Division 13-1

The Narragansett Electric Company
d/b/a National Grid
RIPUC Docket No. 4770
Responses to Division's Thirteenth Set of Data Requests
Issued January 18, 2018

Figure 2

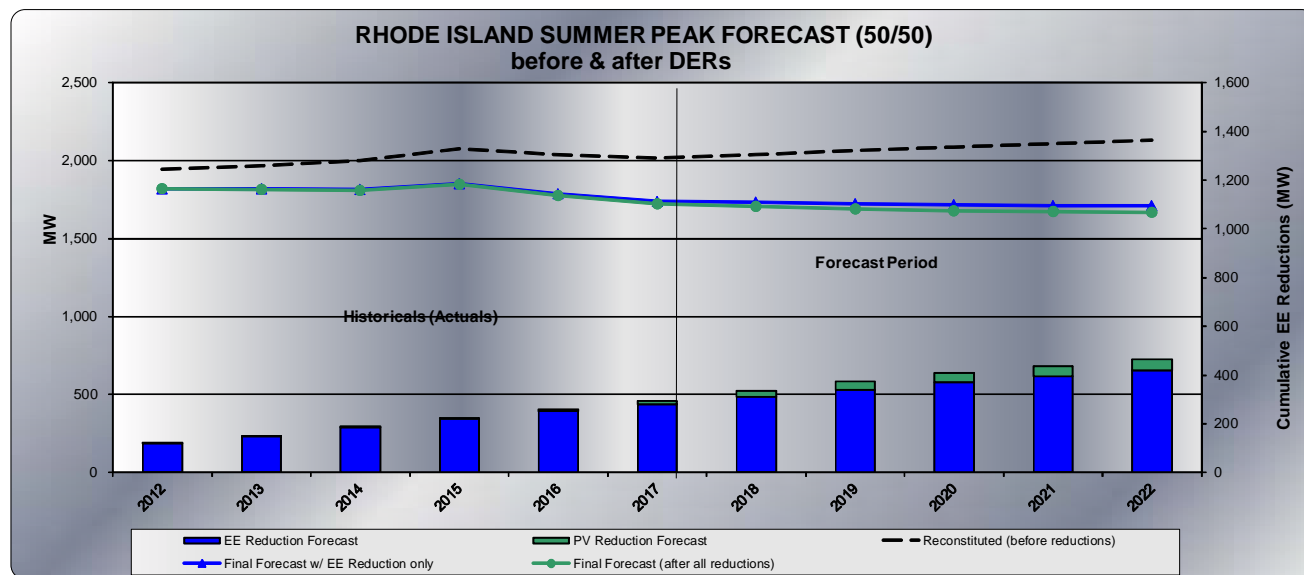
- a) Please provide any additional relevant data that might have been redacted in reference to the demand reduction values.
- b) Referring to Page 2 of 9, please provide additional classification of "PV" considered under "PV reduction" (classification as behind-the-meter and grid-connected).
- c) Please provide any additional information on potential locations in Rhode Island (RI) for behind-the-meter solar additions, along with the expected MW potential at each of these locations.

Figure 2 above shows the expected NECO loads and solar reductions to peaks by year. As of 2017, it is estimated that this technology may have already reduced system peak loads by 16 MW. By 2032 it is expected that these reductions may grow to 66 MW⁵, or about 3% of what load would have been had this technology not been installed. Over the fifteen year planning horizon these reductions lower annual growth from 0.1% to -0.1% per year.
